AMENDMENTS TO THE DRAWINGS

REMARKS

Application No. 10/825,103
Amendment dated June 21, 2007
Reply to Non-Compliant Amendment of June 5, 2007

ANNOTATED SHEET SHOWING CHANGES

FIG.3

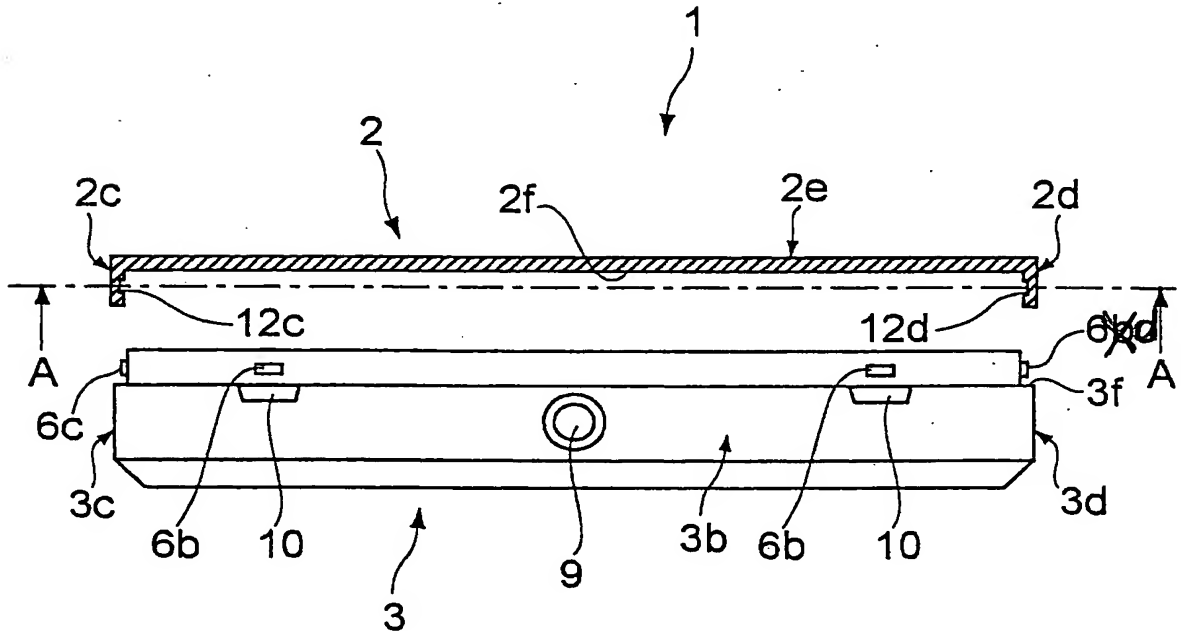
The attached sheet(s) of drawings includes changes to Figs. 3 and 9.
